Car Stereo Service Bulletin

Model: CDX-A100

No. 279

Subject: Part Number Correction - Reference No. 27,
Screw, +M 5 x 6

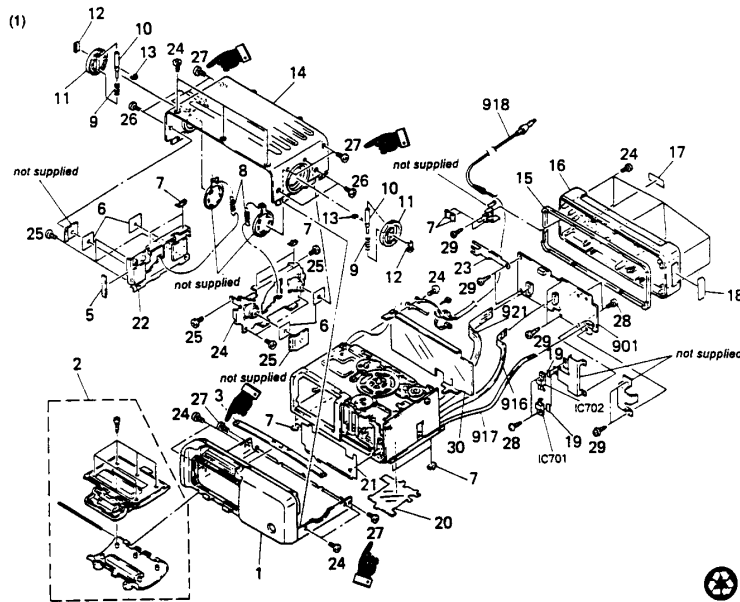
(**) The part number listed on page 34 of the Service Manual for Ref # 27, screw, +m 5 x 6, is incorrect.

Solution: Please note the correct part number as shown below.

REF	DESCRIPTION	PART NUMBER	
		INCORRECT	CORRECT
27	SCREW, +M 5 X 6	3-357-058-01	3-359-058-01
